Re: **Application # 2014-0045.001**
County Route 539 & 547
Block 23601, Lot 1
Jackson Township
Block 70, Lot 18; Block 71, Lot 13; Block 72.01, Lot 14.03 & Block 73, Lot 42
Manchester Township
Block 91, Lot 1 & Block 92, Lot 1
Plumsted Township

AECOM, on behalf of New Jersey Natural Gas (NJNG), is submitting this response to the New Jersey Pinelands Commission (NJPC) to address comments received on November 19, 2015 requesting additional information for Application # 2014-0045.001 and provide updates to the Project design.

NEW JERSEY NATURAL GAS - SOUTHERN RELIABILITY LINK
OCEAN COUNTY, NEW JERSEY

PROPOSED AREA OF TREE CLEARING
AND 6" DEPRESSION
PROFILE VIEW

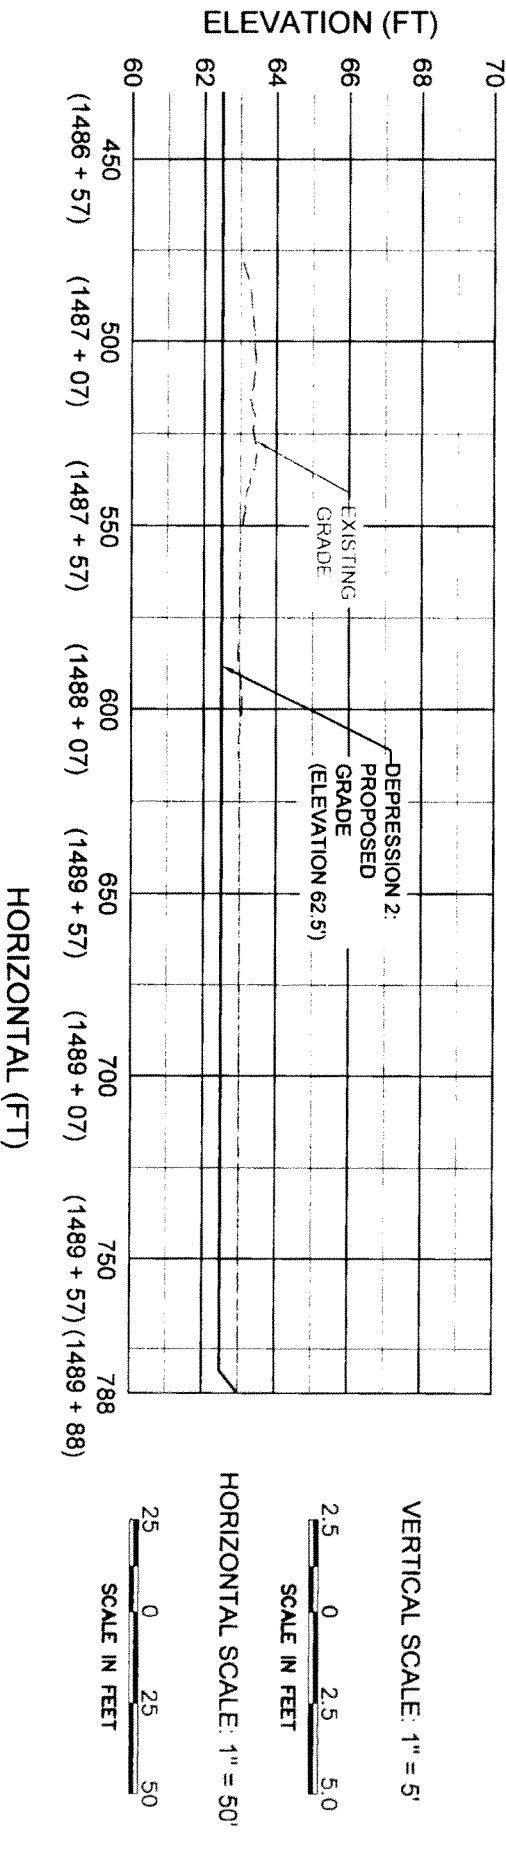
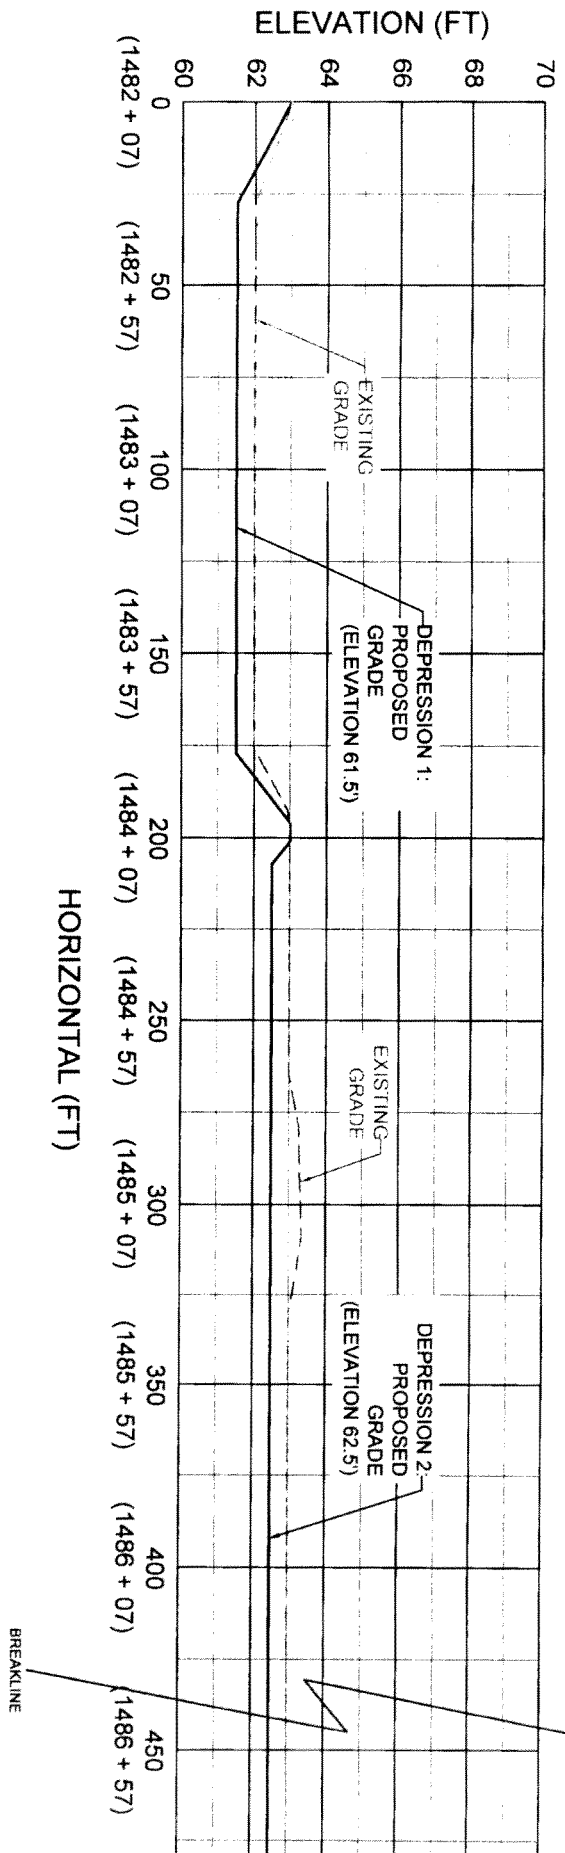
3. **Provide a detail on the plan of the proposed stormwater infiltration swale indicating the length, width and top and bottom elevations of the swale. Please also submit revised soil logs for the infiltration swale which utilize the Munsell Soil Color Chart system to describe the soils observed within the test pits and identify the elevation at which the seasonal high water table was encountered.**

A revised plan with cross-sections and dimensions detailing the length and top and bottom elevations of the stormwater infiltration swale are included in **Attachment C**.
